HISTORIC AND DESIGN REVIEW COMMISSION

HDRC CASE NO: 2018-437
ADDRESS: 429 MADISON ST
LEGAL DESCRIPTION: NCB 746 BLK 5 LOT 7
ZONING: RM-4,HS
CITY COUNCIL DIST.: 1
DISTRICT: King William Historic District
LANDMARK: Wells, W L - House
APPLICANT: Jay Monday
OWNER: Tom and Jan Patterson
TYPE OF WORK: Exterior Alterations to the Existing Carriage House
APPLICATION RECEIVED: August 29, 2018
60-DAY REVIEW: October 28, 2019
REQUEST:

The applicant is requesting a Certificate of Appropriateness for approval to modify the existing carriage house to include a small addition, exterior modifications and fenestration modifications.

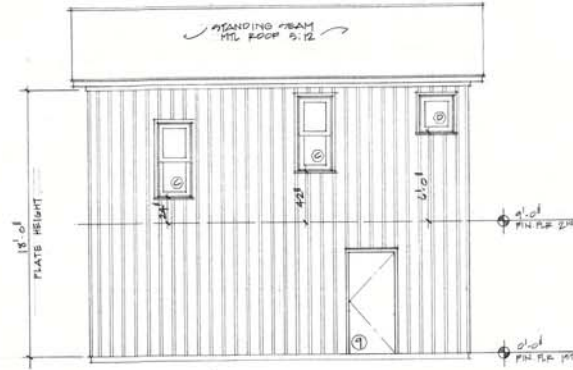
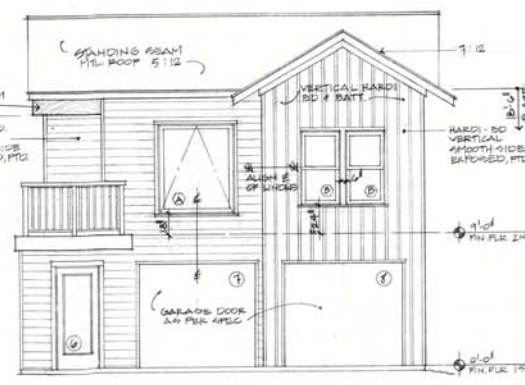
- f. **FENESTRATION MODIFICATIONS** – On the north and south facades, the applicant has proposed to install fixed windows. Staff finds windows at these locations appropriate; however, one over one windows featuring widths found historically on the site should be installed.

4 EXTERIOR ELEVATION - STREET VIEW
A2 NO. 1/4" = 1'-0"

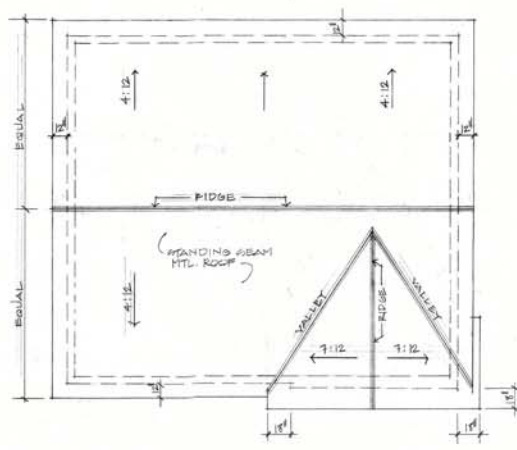
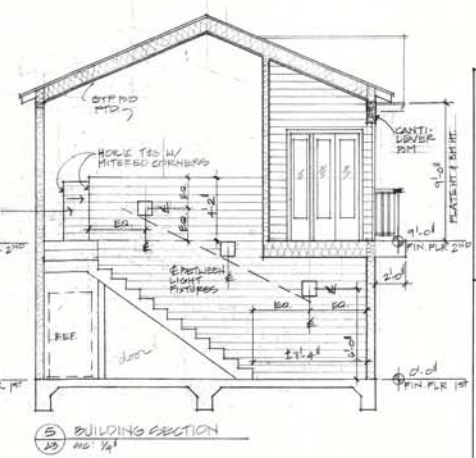
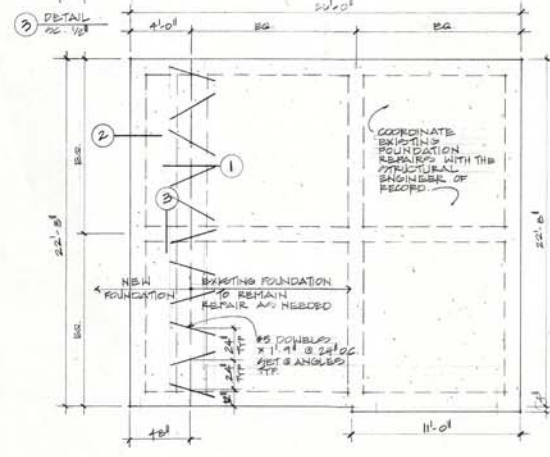
- c. **FENESTRATION MODIFICATIONS** – The applicant has proposed to replace the existing, single window centered under the gable with double windows. Staff finds this to be appropriate; however, the windows should be separated by a mullion of at least six (6) inches in width.

- d. **FENESTRATION MODIFICATIONS** – To the immediate right of the proposed double windows, the applicant has proposed to install a large fixed window. Staff finds the proposed window opening to be appropriate; however, staff finds that the opening should feature two, one over one windows rather than a large fixed window.

- e. **FENESTRATION MODIFICATIONS (Garage doors)** – Immediately below the proposed fixed window, the applicant has proposed to install an additional garage door. Staff finds this installation to be appropriate. Staff recommends either a wood or metal door.

- i. That the fixed window on the street facing elevation be modified to feature two, one over one windows separated by a mullion of six (6) inches in width, to match the double windows beneath the gable as noted in finding d.
- ii. That the proposed garage door consist of wood or metal construction.
- iii. That the proposed fixed windows be modified to feature sash windows with one over one profiles and widths comparable to originally found on the historic structure.
- iv. That the standing seam metal roof should feature panels that are 18 to 21 inches in width, seams that are 1 to 2 inches in height, a crimped ridge seam and a standard galvalume finish.
- v. That the Hardie siding should feature a smooth finish and an exposure of four inches, or an exposure to match that found on the historic house and that the board and batten siding feature boards that are 12 inches wide and battens
